MISSISSAUGA BUS RAPID TRANSIT

ENVIRONMENTAL ASSESSMENT ADDENDUM

March 2010

McCormick Rankin Corporation
in association with
Ecoplans, Ltd.

MRC McCormick Rankin Corporation	MISSISSAUGA Transportation and Works	DATE: September 2008	MISSISSAUGA BRT PROJECT ENVIRONMENTAL ASSESSMENT ADDENDUM	FIGURE 7-2
	GO Transit	SCALE: N.T.S.	RECOMMENDED ALTERNATIVE BUSWAY ALIGNMENT - OVER TOMKEN

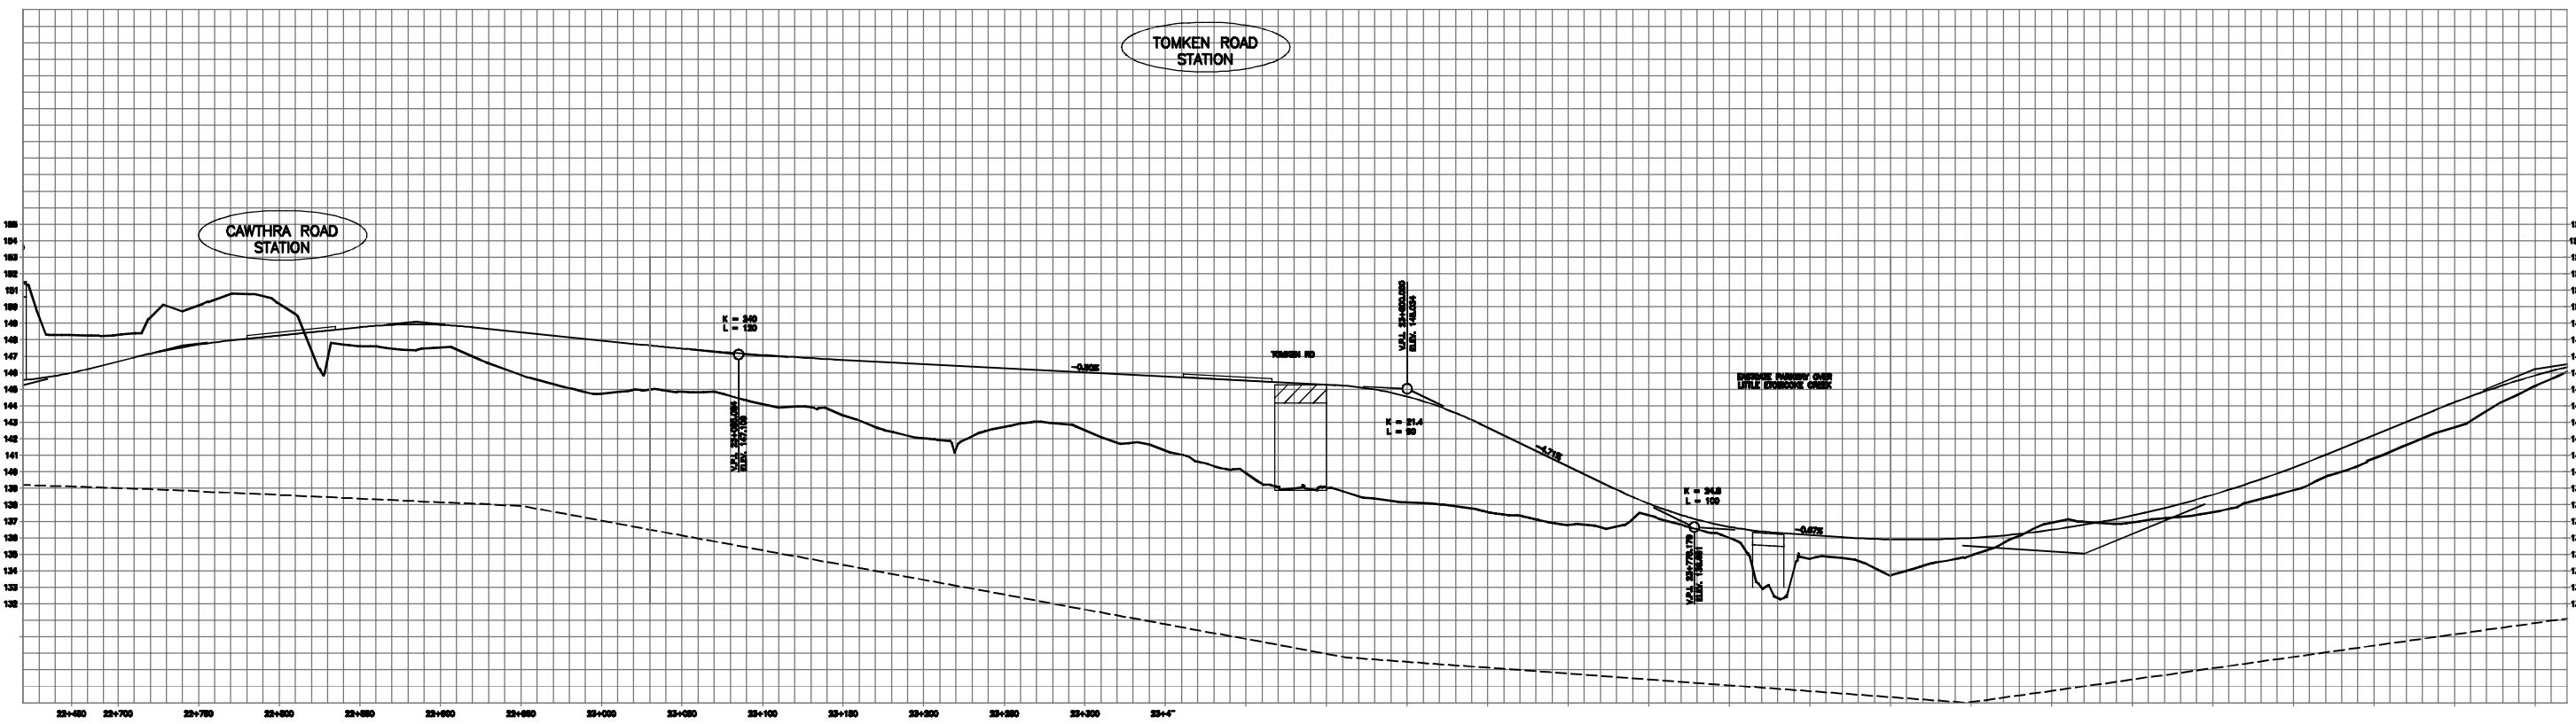
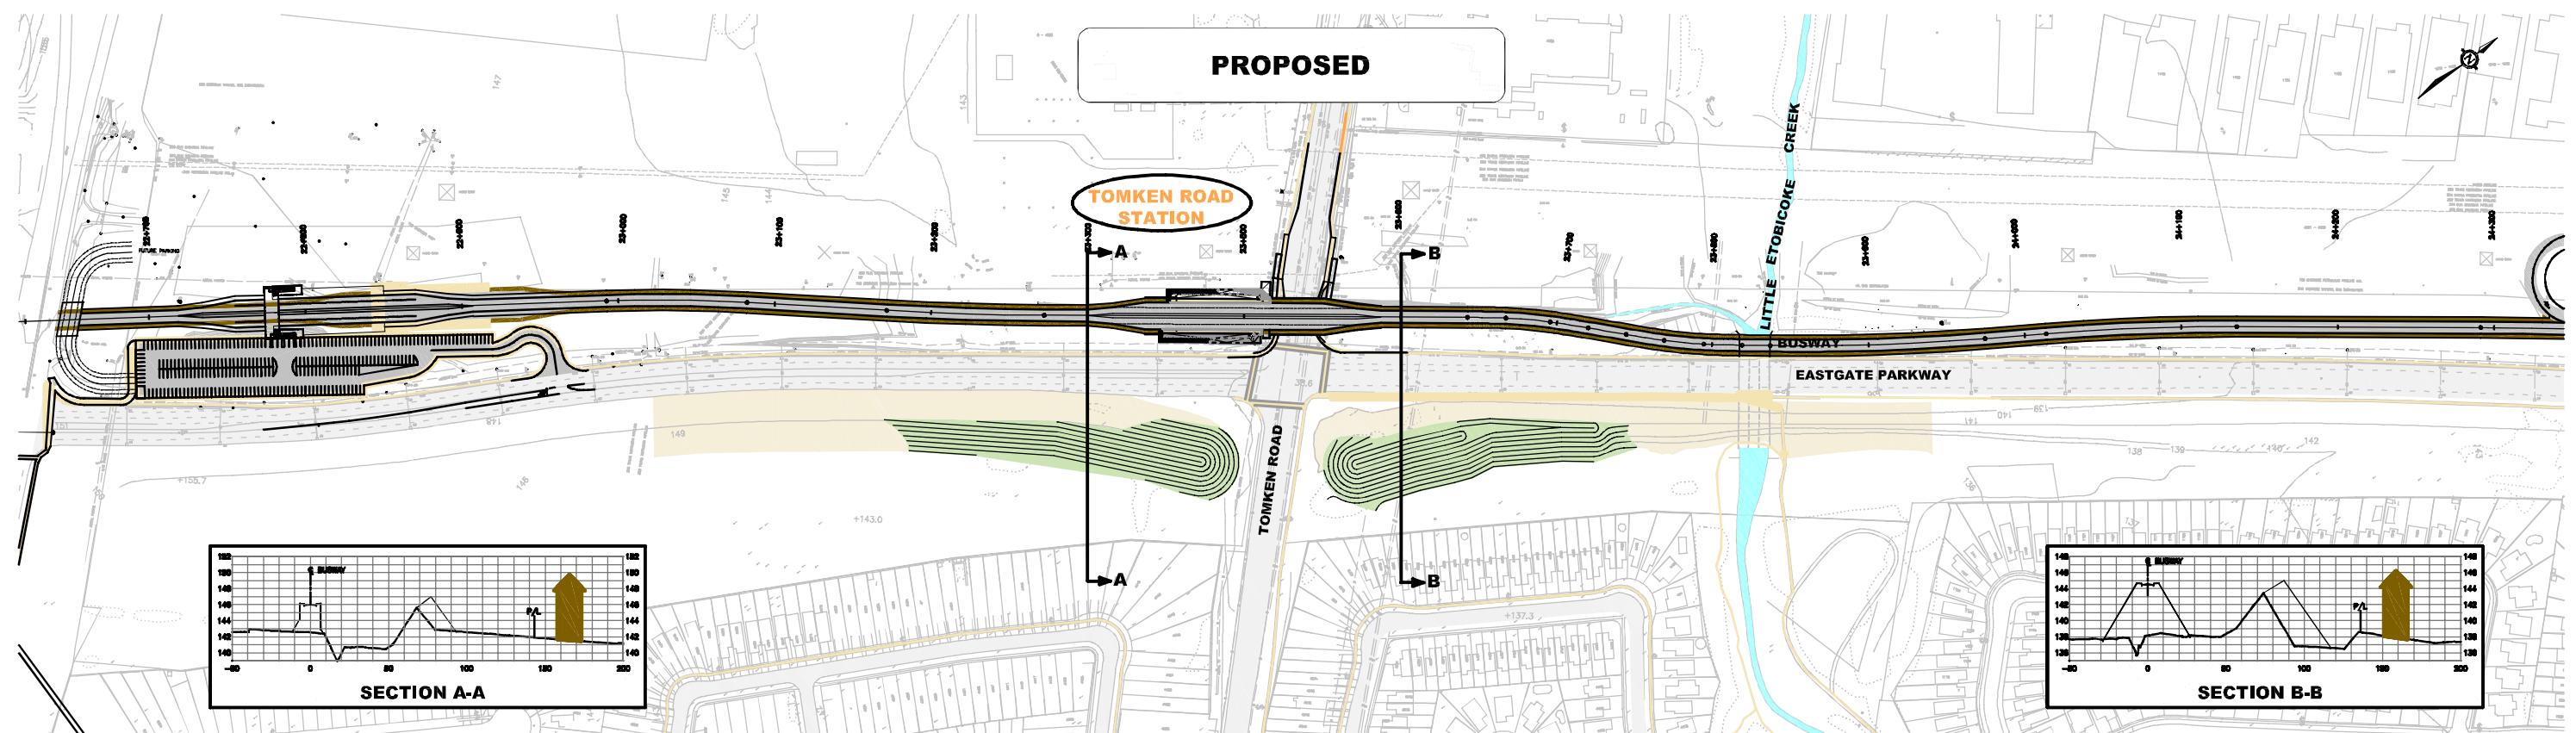
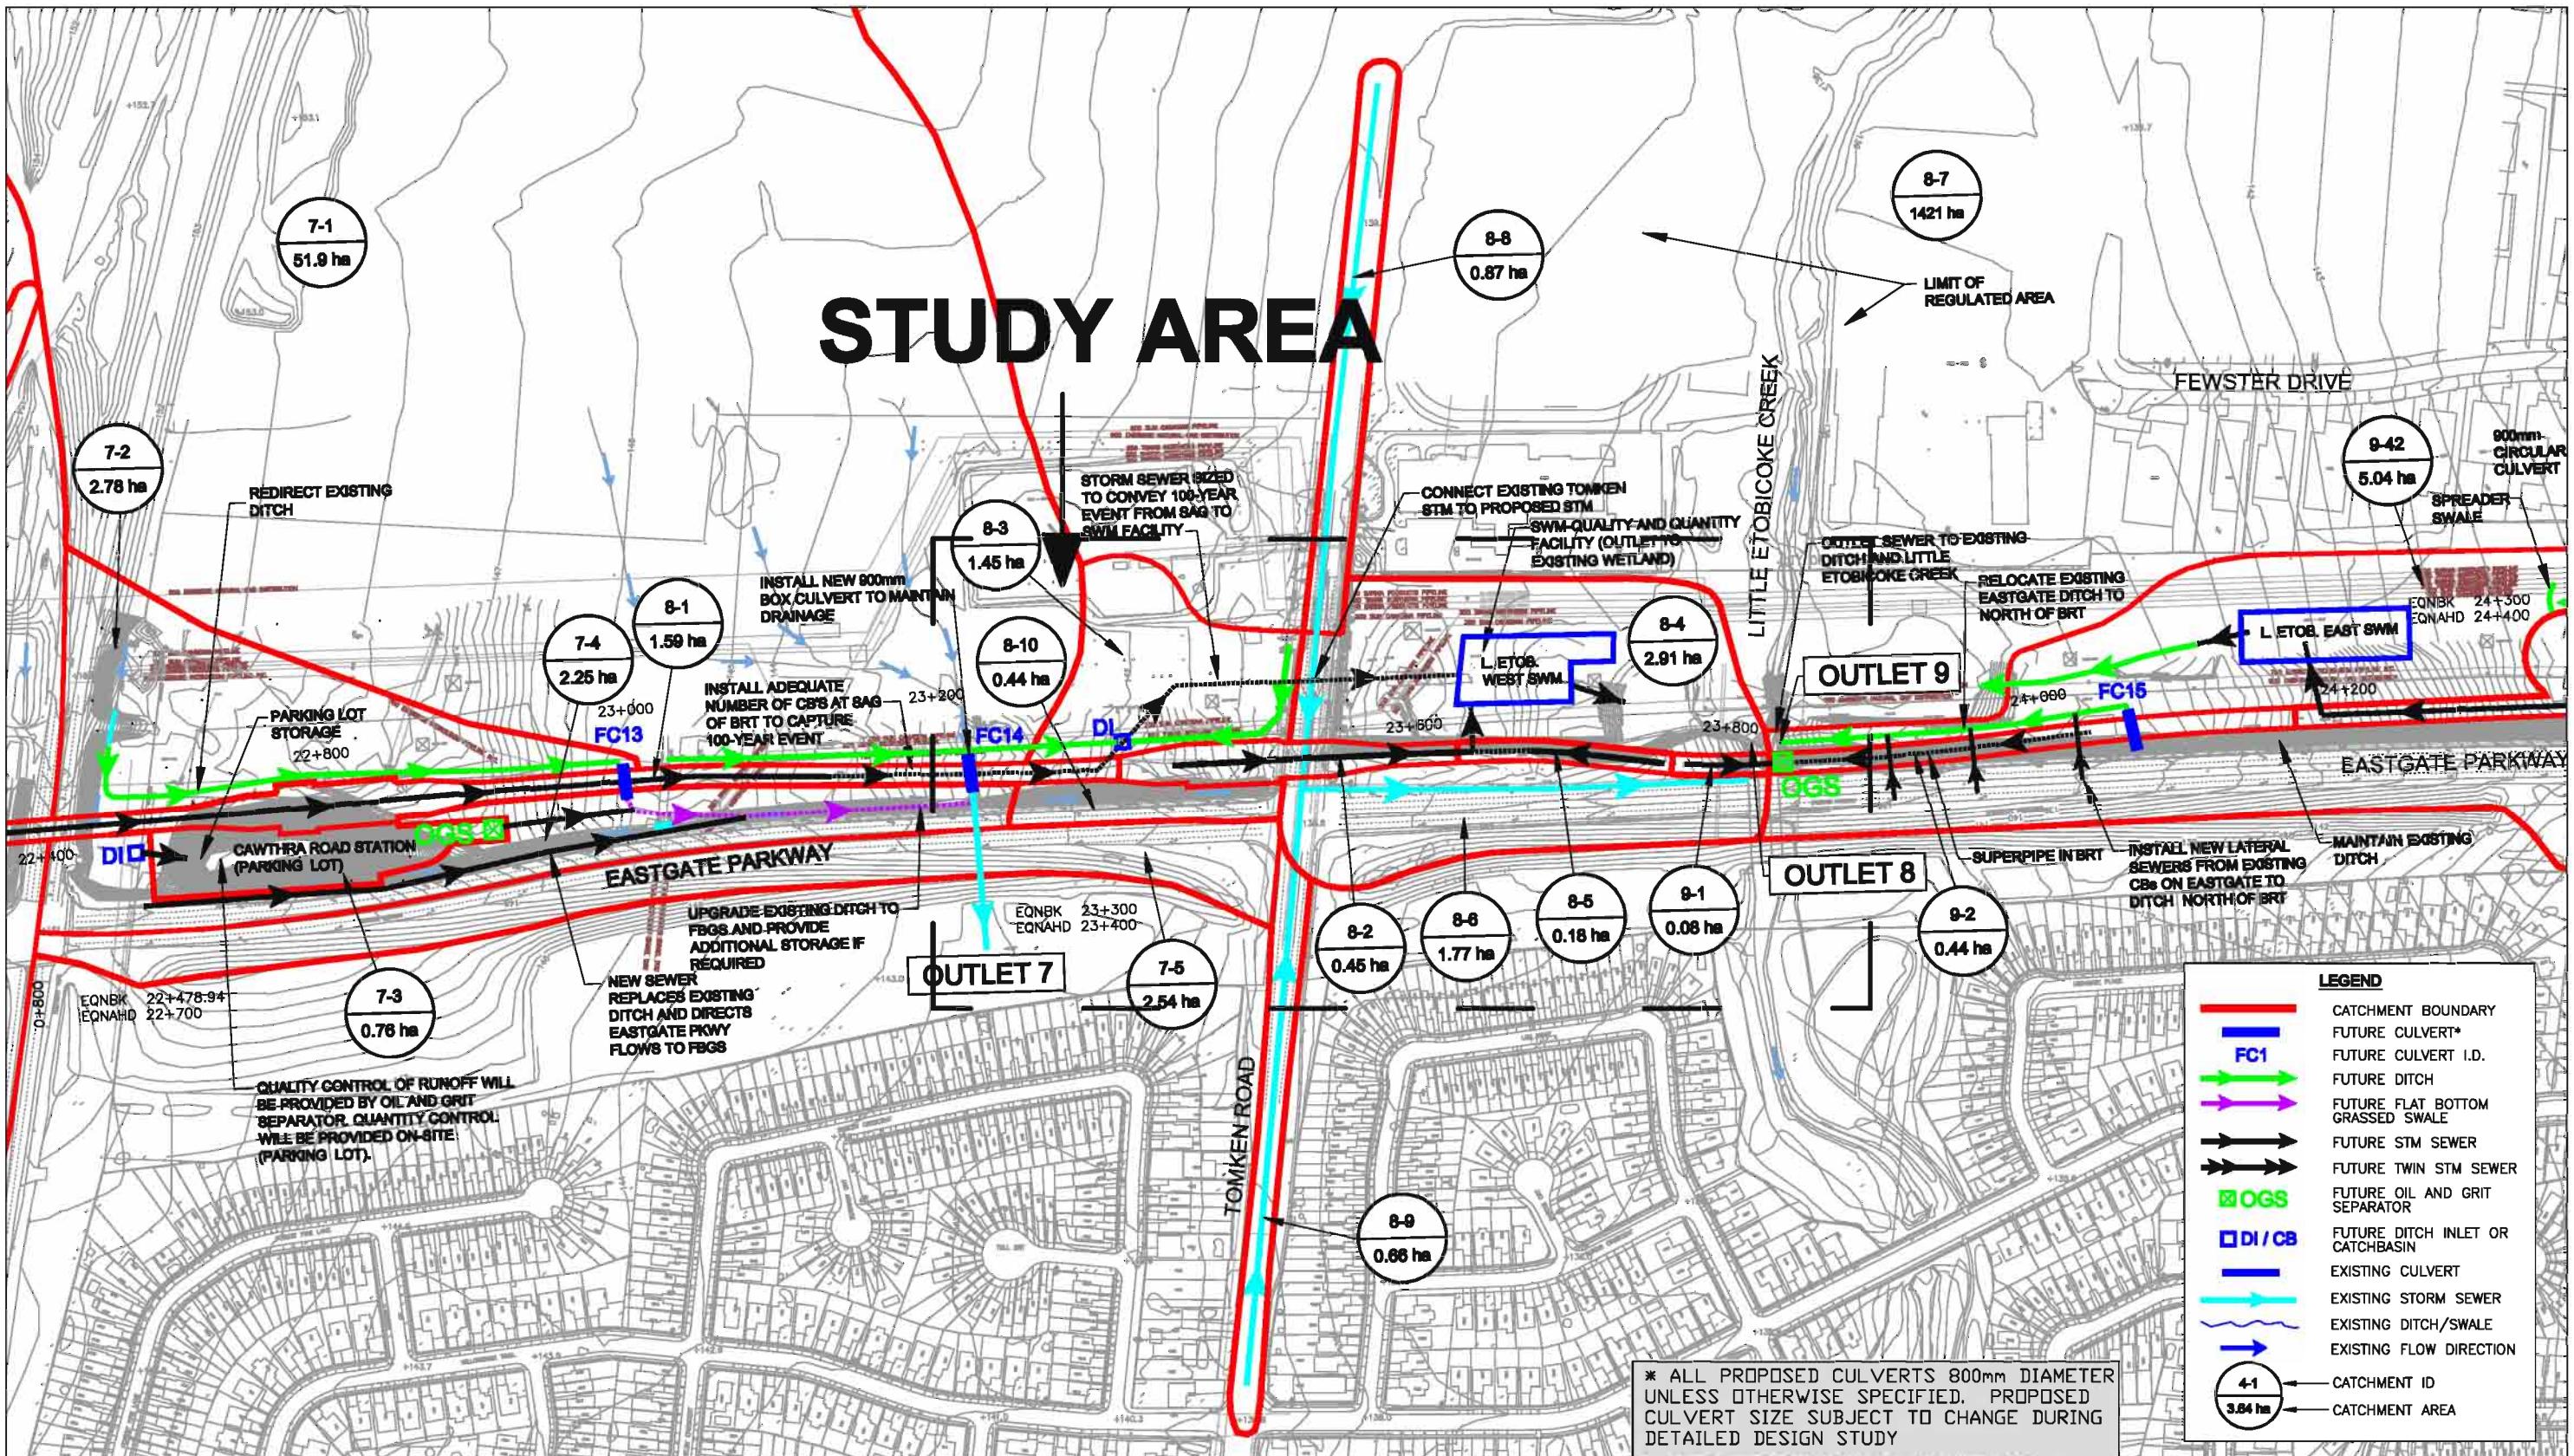
Recognizing the need to continue to protect the residential community south of Eastgate Parkway from noise and visual intrusion, the existing berm south of Eastgate Parkway would be extended and supplemented by visual screening / landscaping along the north part of Tomken Road. This would screen the view of the tops of double decker buses along the busway from the second-floor windows of south side residences (as shown on Figure 7-2).

The proposed alternative is to lift the busway over Tomken Road. The station location and busway alignment would not change. The recommended alternative is shown on Figure 7-2.
